To: General Purposes Committee **Date:** May 24, 2016
From: Phyllis L. Carlyle **File:** 12-8350-05-AMANDA
General Manager, Law and Community Safety #/Vol 01
Re: **Non-Farm Use Fill Application by Sixwest Holdings Ltd. No. BC1025692 for
Property Located at 14791 Westminster Highway**

RE: Response to McTavish Resource & Management Consultants Ltd. Assessment of 'Non-Farm use fill application' at 14791 Westminster Hwy, Richmond

FIGURE 1

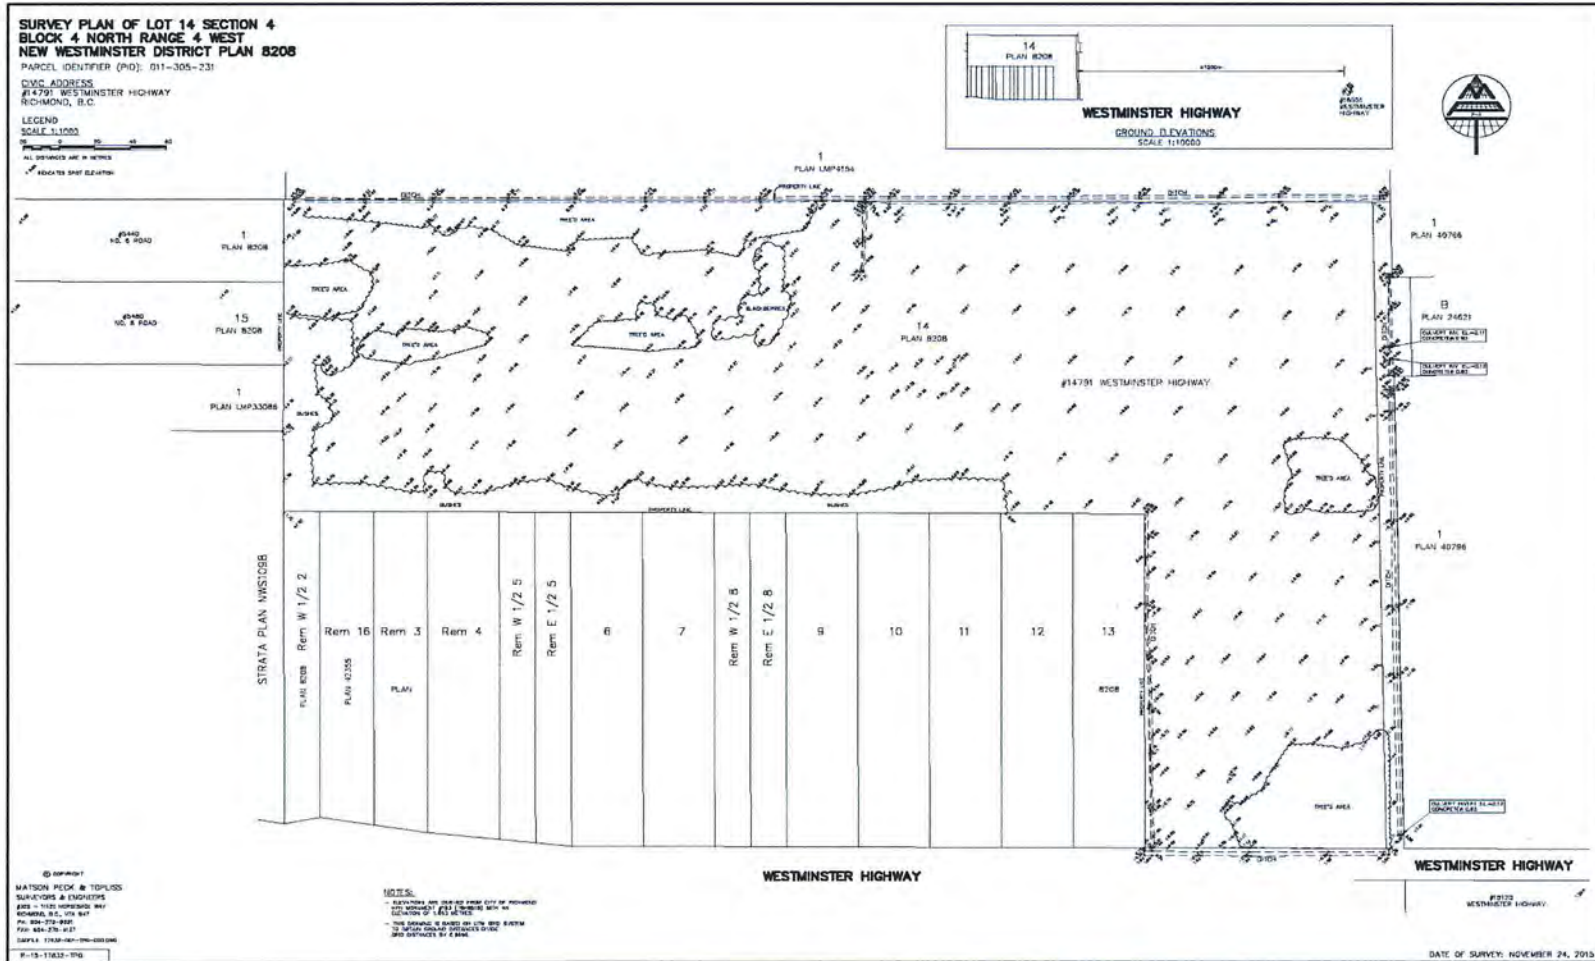
1 A detailed topographic survey referenced to geodetic datum.

This has been completed. See Figure 1.

The survey confirms that the ground is at a low elevation, relative to adjacent properties. The BCLS surveyor confirms that the average elevation of the property is 0.6 m, which is low for Richmond. Other off-site elevations were measured, as follows:

Figure 1 shows that about 70% of the land area lies between 0.5 and 0.7 m elevation. The remaining 30% - mainly in the western portion – lies below 0.5 m.

FIGURE 2A

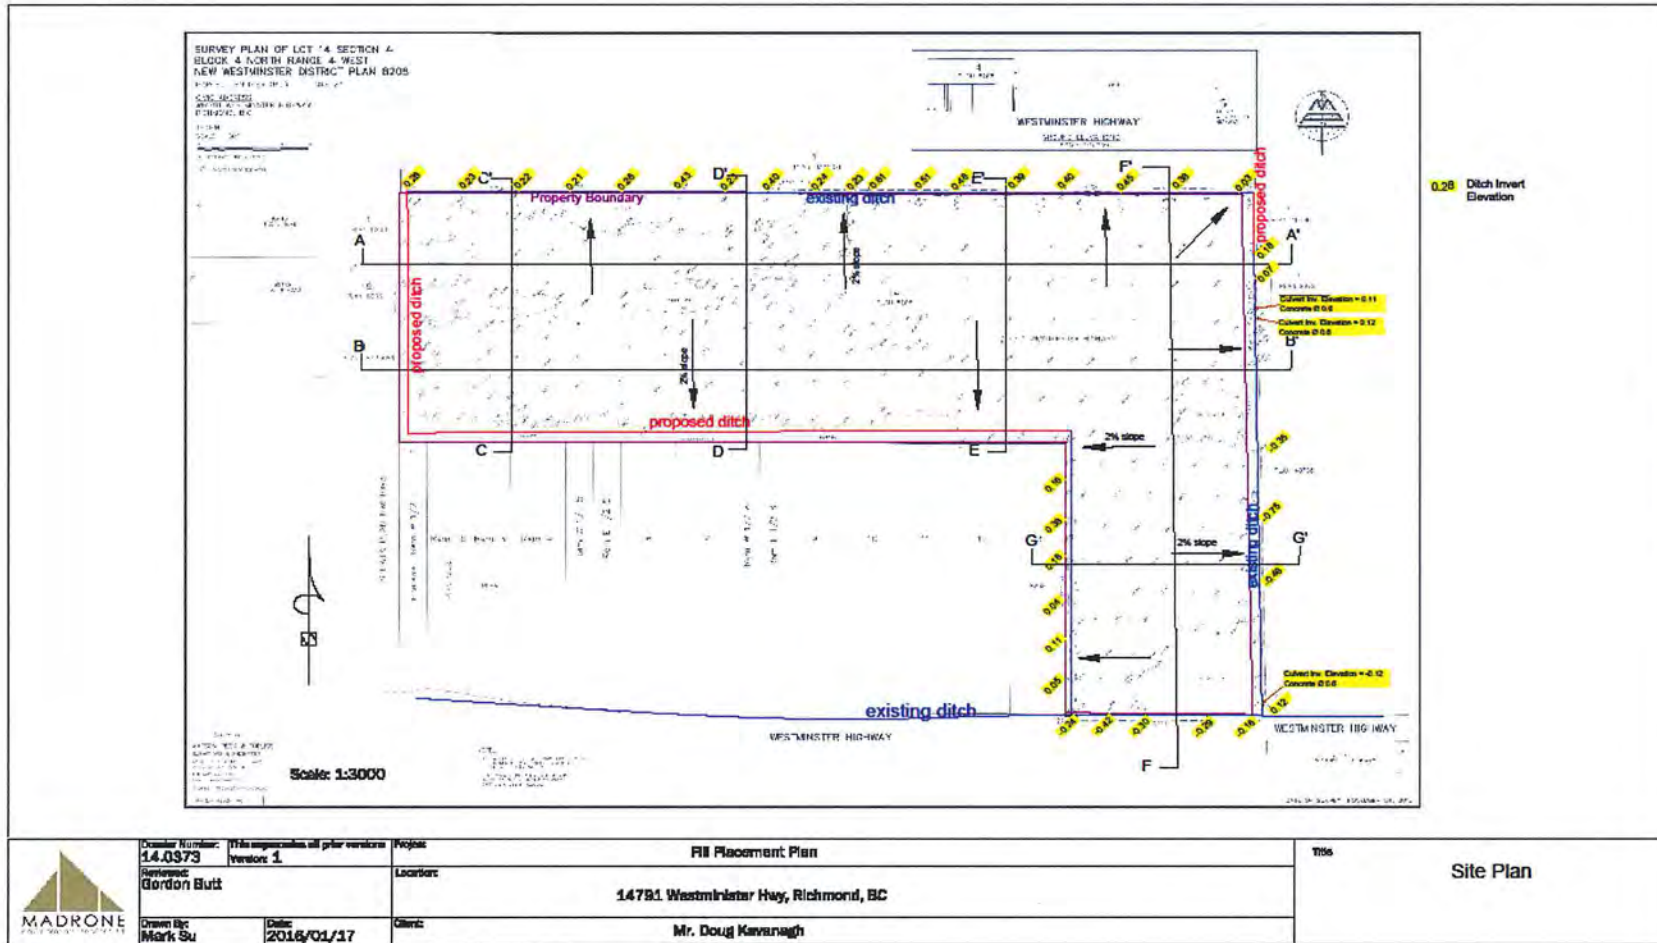
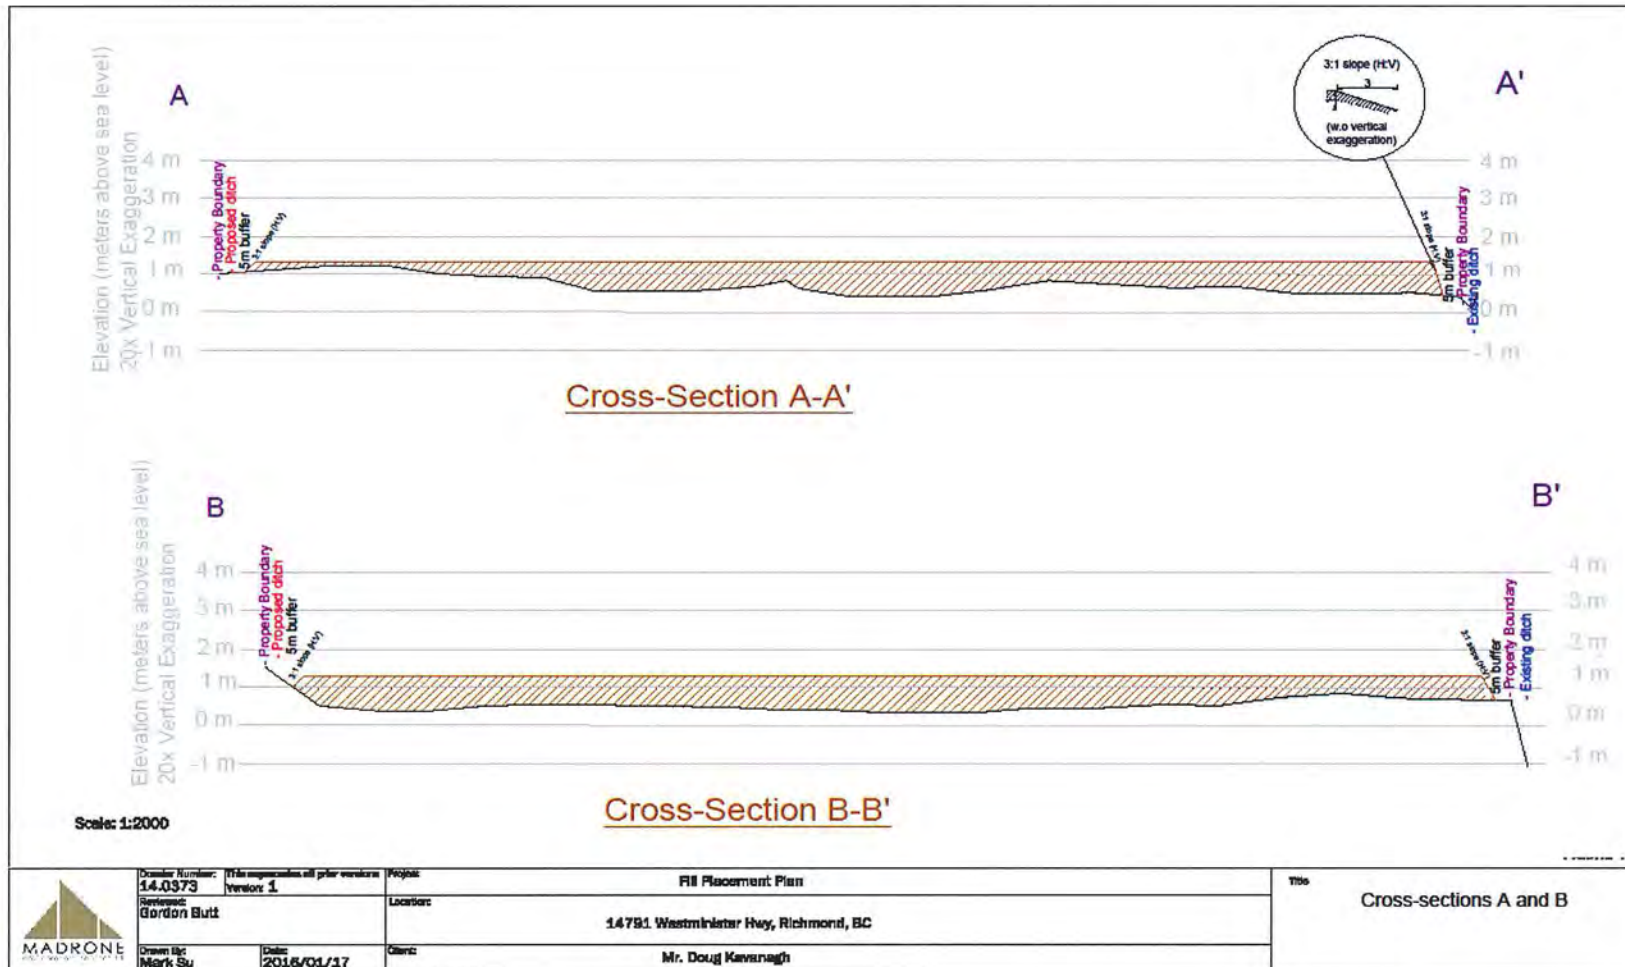
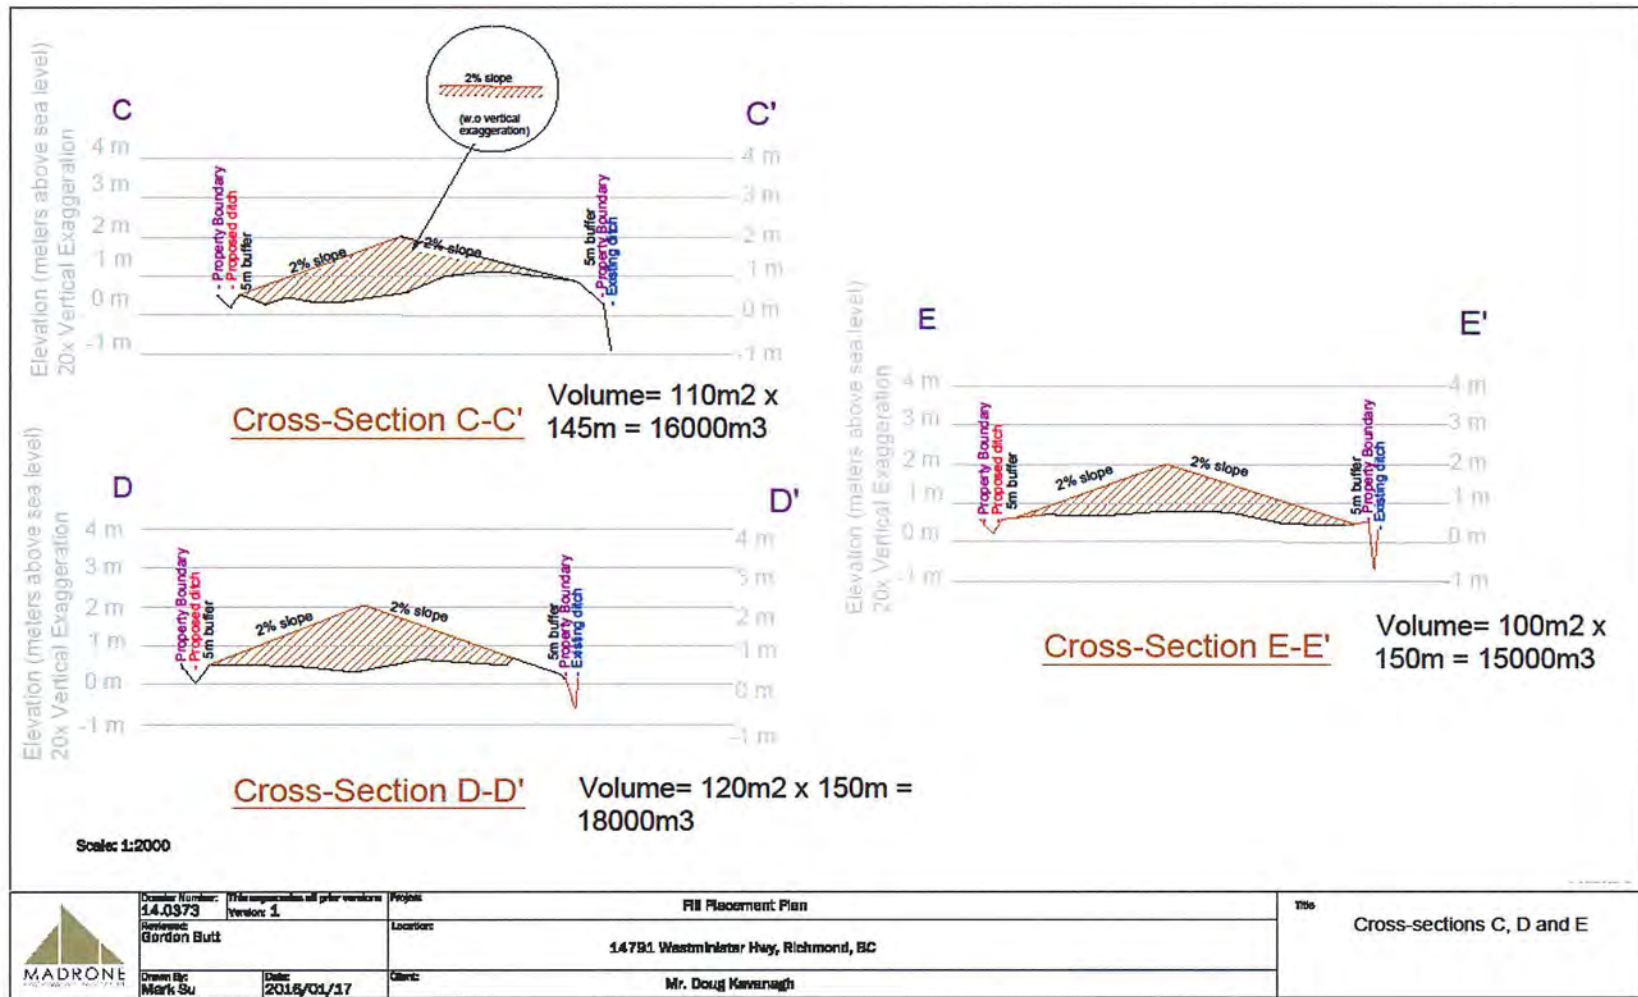
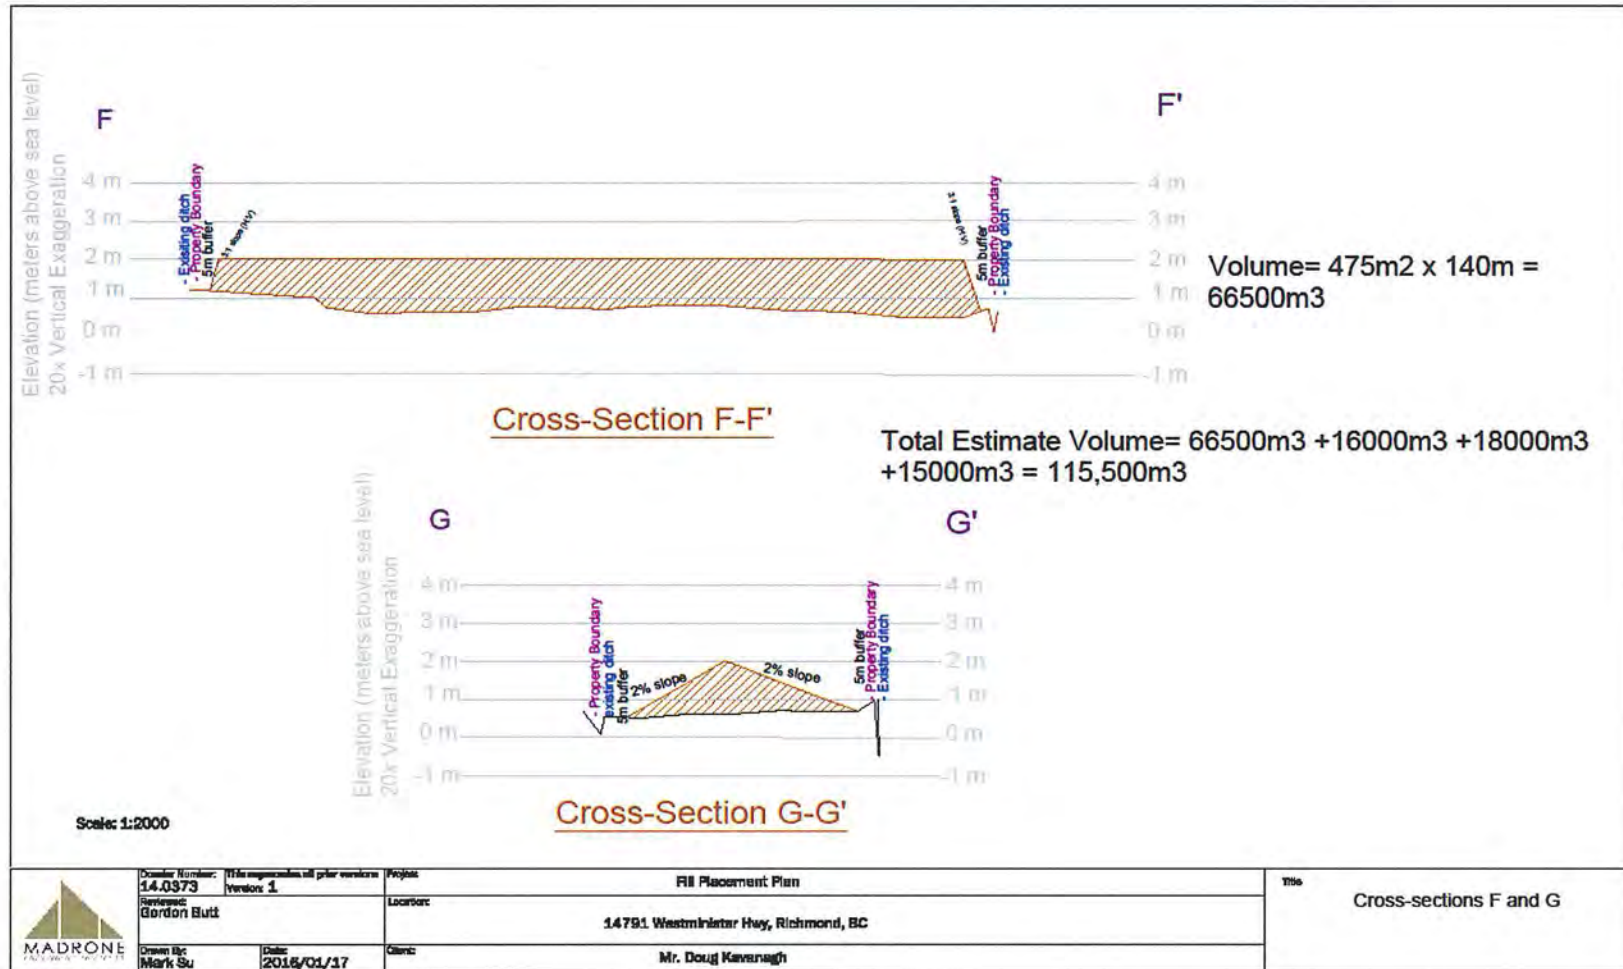
2 Elevations and cross-sections showing the finished grades with topographic reference to geodetic elevations.

5 A detailed drainage plan including the invert levels of all drainage pipes;

See Figure 2a, b, c and d. These cross-sections are a more detailed version of a similar diagram that was included in the original submission. It shows the topographic variation in the ground surface, as provided by the detailed geodetic survey. The slope away from the centre has been increased to 2% to allow better drainage towards the periphery.

Figure 2a shows existing and proposed ditches on the subject site. An existing ditch runs the length of the northern boundary. Invert elevations range from 0.61 to 0.03 (in the northeastern corner).

Figure 2a shows the location of existing and proposed ditches. Figures 2b through 2d show cross-sections of the proposed fill. No in-field drainage is planned; however, the fill will be graded to 2% grades from a central east-west ridge to allow for drainage to adjacent ditches.

FIGURE 3

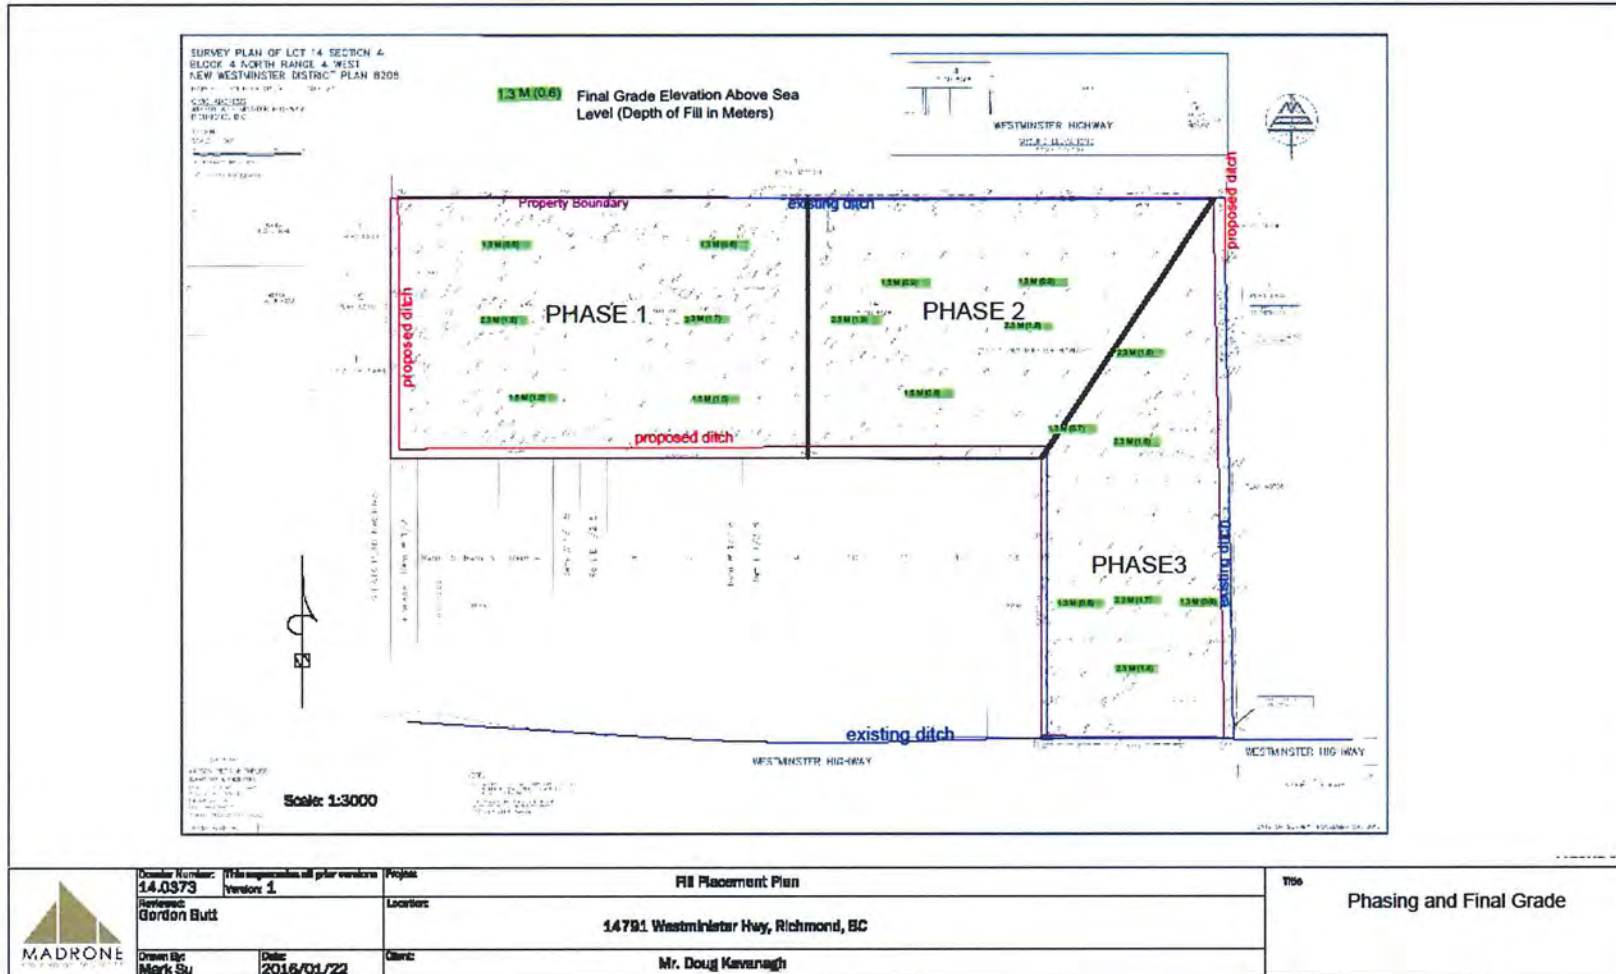
3 Site Phasing details referenced to every 2 to 3 years with the finished grade of each phase indicated.

Figure 3 shows the phasing plan along with final grades and depths of fill at selected locations.

The fill operation will extend from west to east from this access point. Figure 3 shows the areas of three broad phases. The first operation will be construction of a road to allow machine access onto the property. The road would lead to as-yet undetermined points or nodes with sufficient area to allow machine operation (we prefer to leave these details to the contractor). All topsoil under the road footprint will be stripped and windrowed adjacent to initial road construction. From this point, stripping and stockpiling of topsoil would proceed systematically in a specific pattern developed by the contractor (Hexall Construction, a trusted City of Richmond Contractor).

Fill will be imported, dumped and temporarily stockpiled near each point or node and after adjacent areas are stripped, fill will be pushed out using dozers and excavators. The contractor will determine exact areas of topsoil stripping and fill placement, but it will be in a progressive fashion. The fill thickness will roughly conform to the elevations and depths shown in Figure 3.
